Well Name: OUTRIDER 27 FED	Well Location: T24S / R32E / SEC 27 / SWSW /	County or Parish/State: /
Well Number: 114H	Type of Well: OIL WELL	Allottee or Tribe Name:
Lease Number: NMNM016353	Unit or CA Name:	Unit or CA Number:
US Well Number: 3002550236	Well Status: Drilling Well	Operator: XTO ENERGY INCORPORATED

Sundry ID: 2745077

Type of Submission: Notice of Intent	Type of Action: APD Change
Date Sundry Submitted: 08/08/2023	Time Sundry Submitted: 11:55
Date proposed operation will begin: 08/08/2023

<b>OPERATOR'S NAME:</b>	XTO Energy Incorporated
<b>WELL NAME &amp; NO.:</b>	Outrider 27 Fed 114H
<b>LOCATION:</b>	Sec 27-24S-32E-NMP
<b>COUNTY:</b>	Lea County, New Mexico

WELL LOCATION AND ACREAGE DEDICATION PLAT

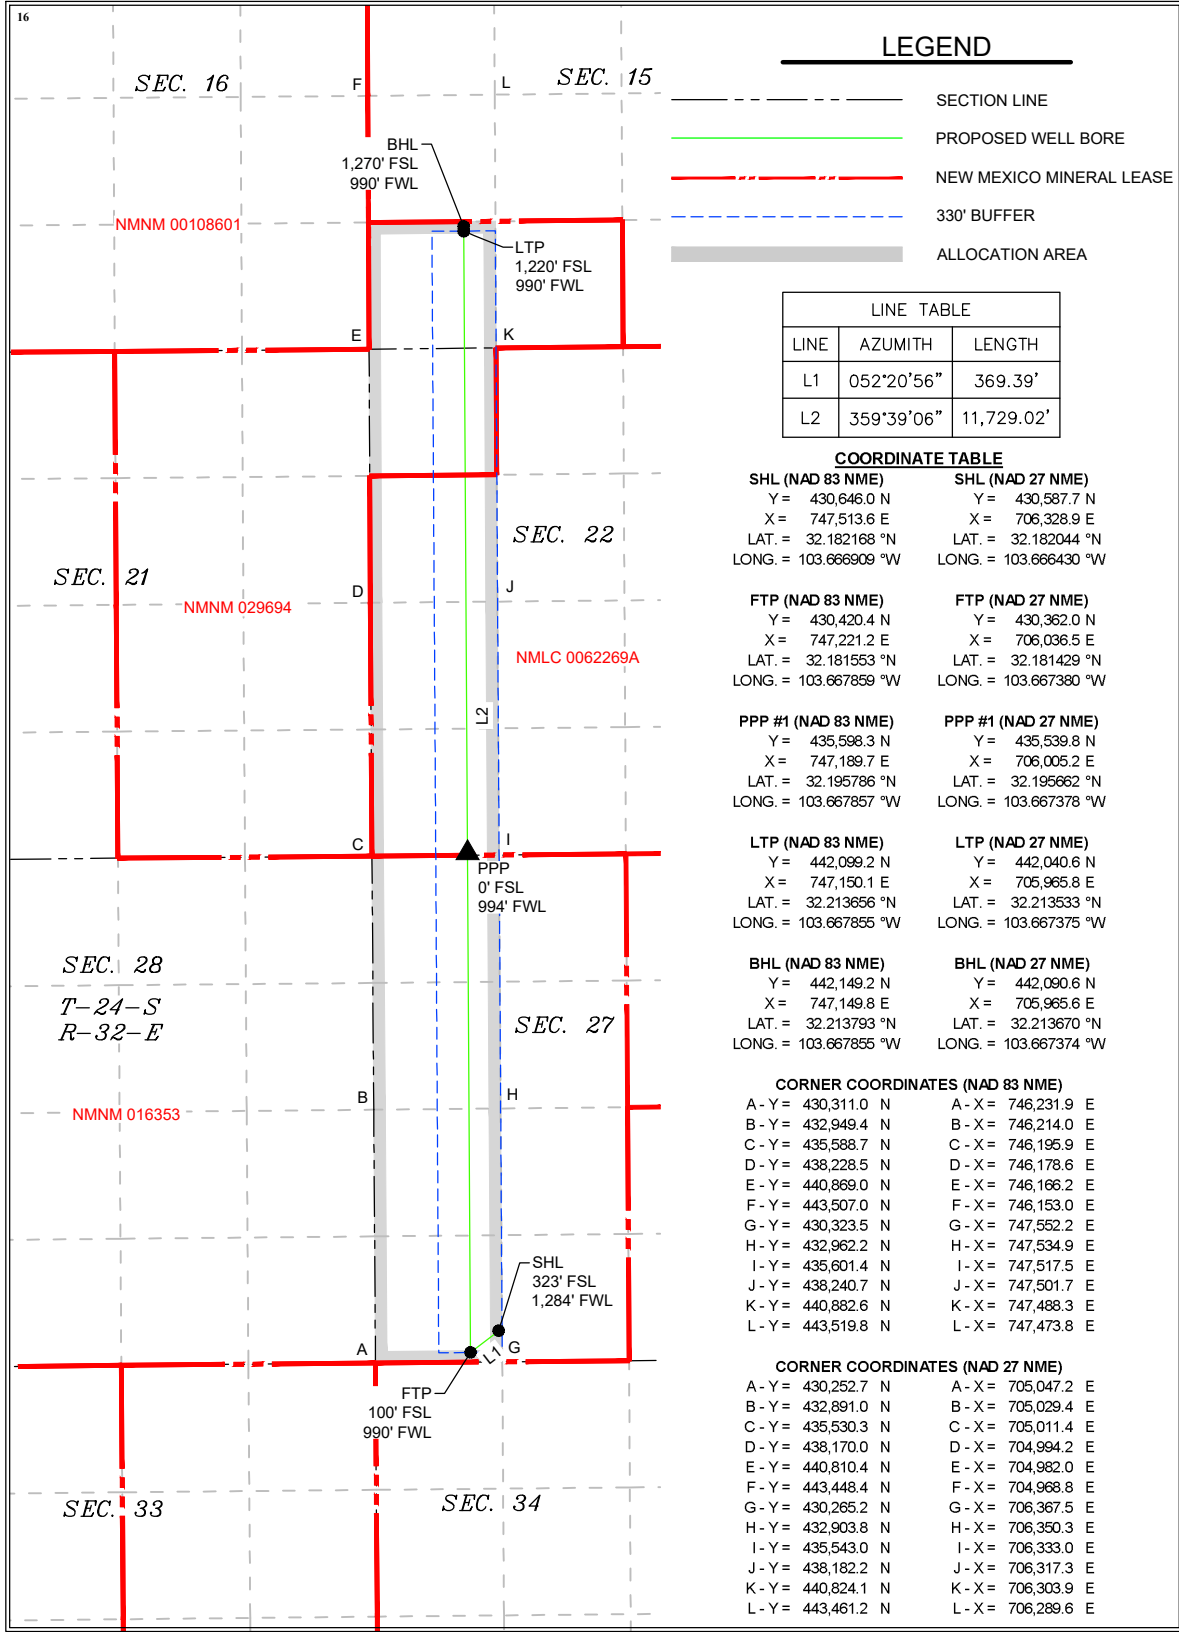
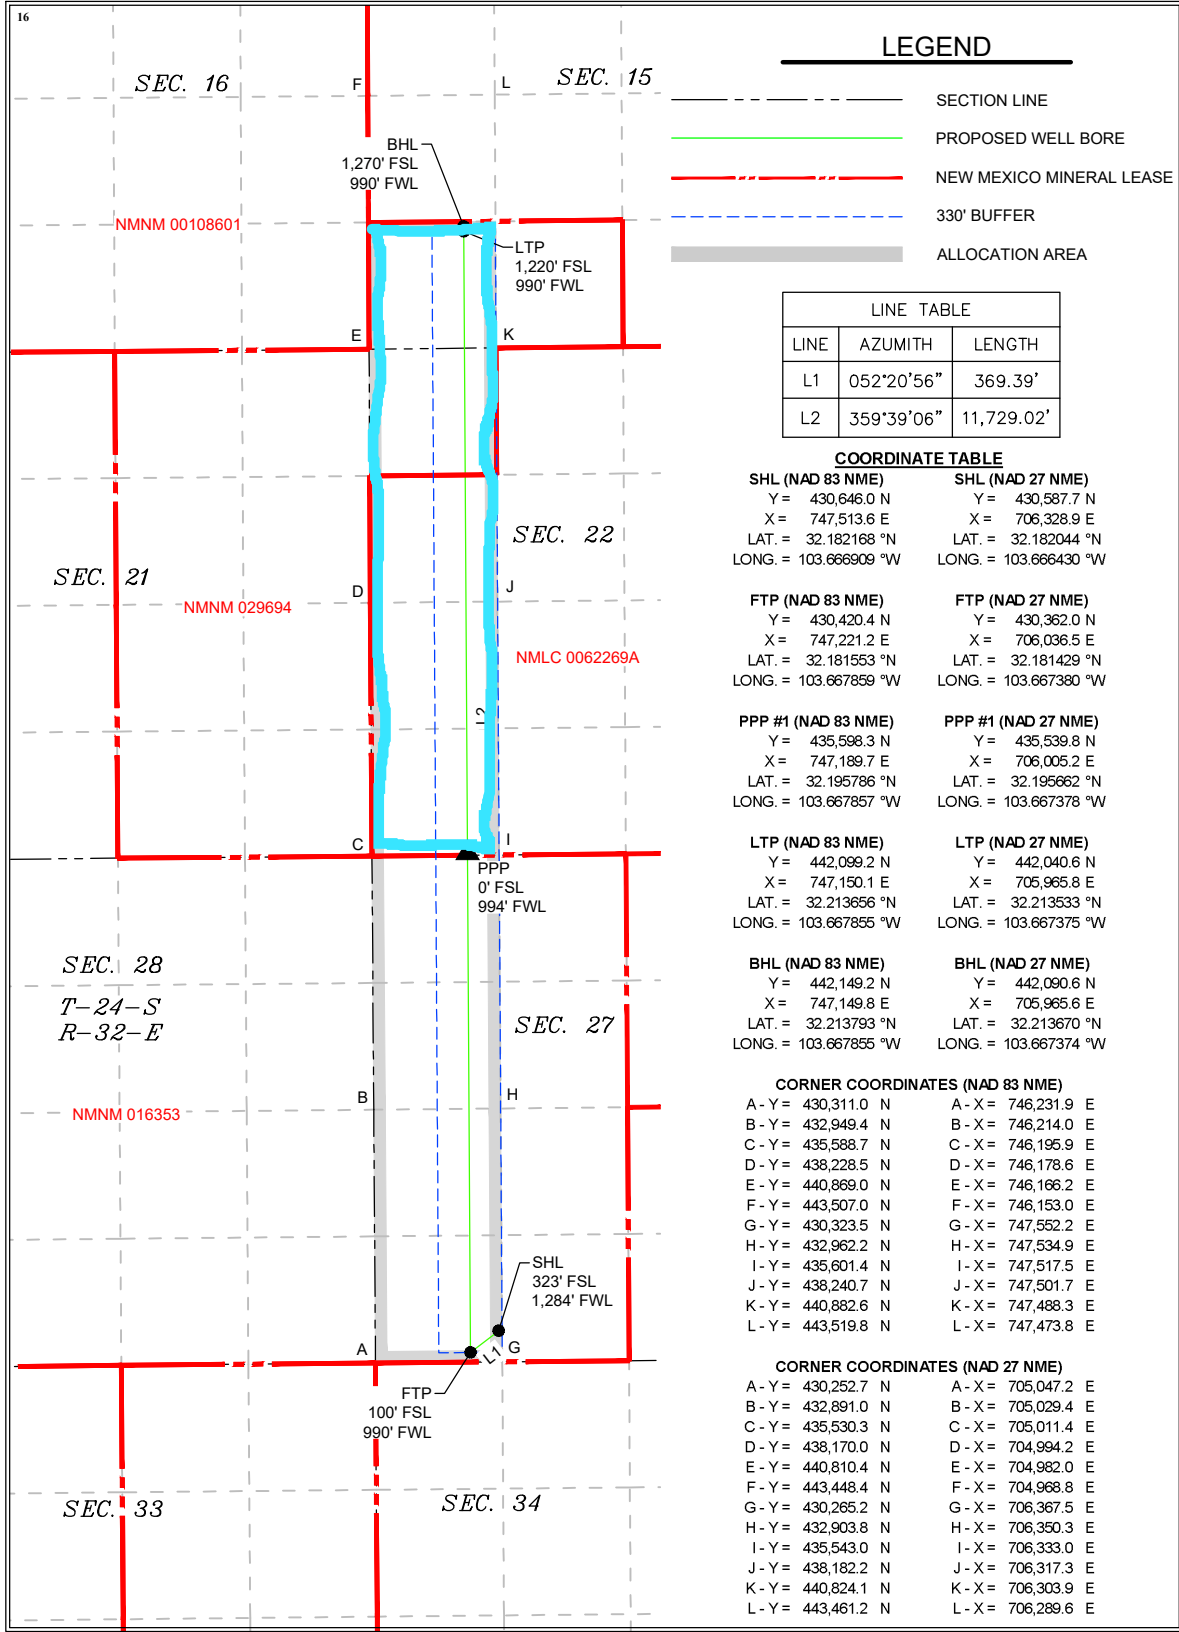
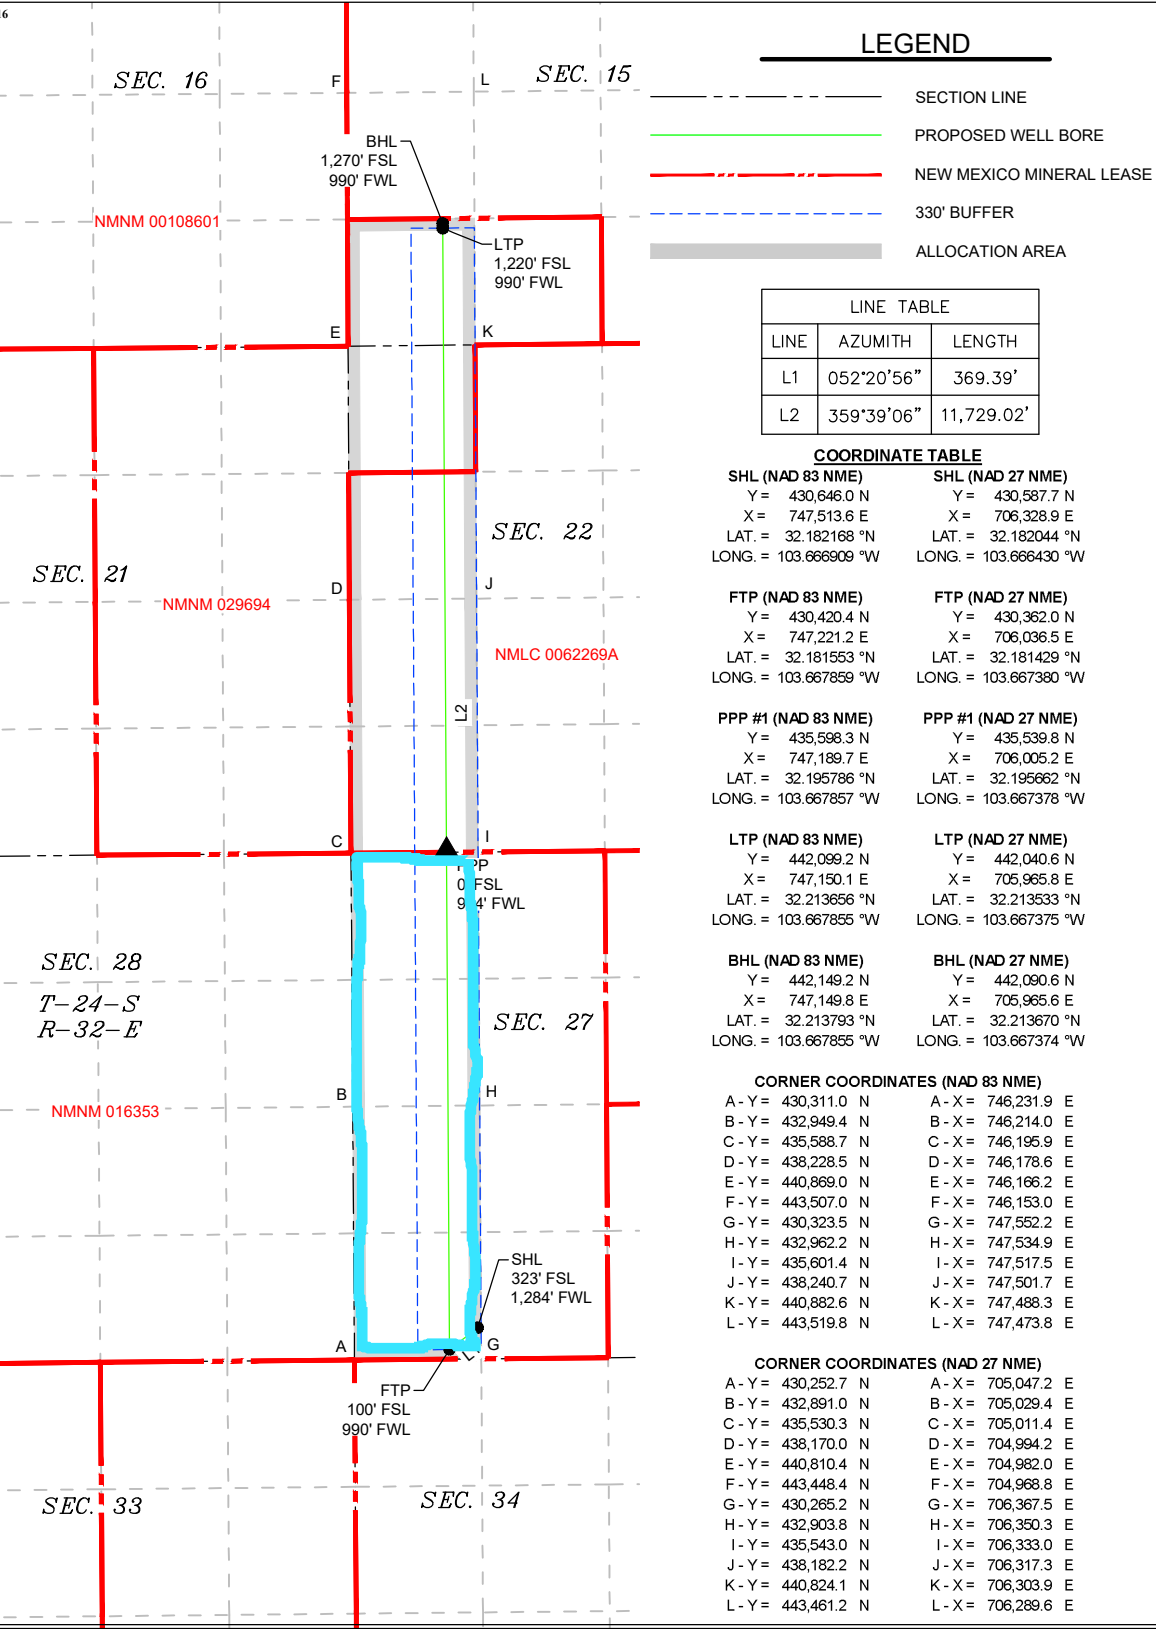
Pool Change: Fr/Mesa Verde; Wolfcamp (98252) to WC-25 G-06 S253206; Bone Spring (97899)

FTP: fr/50FSL & 2310FWL to 100FSL & 990FWL, NMNM016353

LTP: fr/50FNL & 2310FWL to 1220FSL & 990FWL, NMLC029694

BHL: fr/50FNL & 2310FWL to 1270FSL & 990FWL, Section 15-T24S-R32E NMLC029694

<sup>1</sup> API Number 30-025-	<sup>2</sup> Pool Code 97899	<sup>3</sup> Pool Name WC-25 G-06 S253206; BONE SPRING
<sup>4</sup> Property Code	<sup>5</sup> Property Name OUTRIDER 27 FED	<sup>6</sup> Well Number 114H
<sup>7</sup> OGRID No. 005380	<sup>8</sup> Operator Name XTO ENERGY, INC.	<sup>9</sup> Elevation 3,529'

<sup>11</sup> Bottom Hole Location If Different From Surface									
UL or lot no. M	Section 15	Township 24S	Range 32E	Lot Idn	Feet from the 1,270	North/South line SOUTH	Feet from the 990	East/West line WEST	County LEA
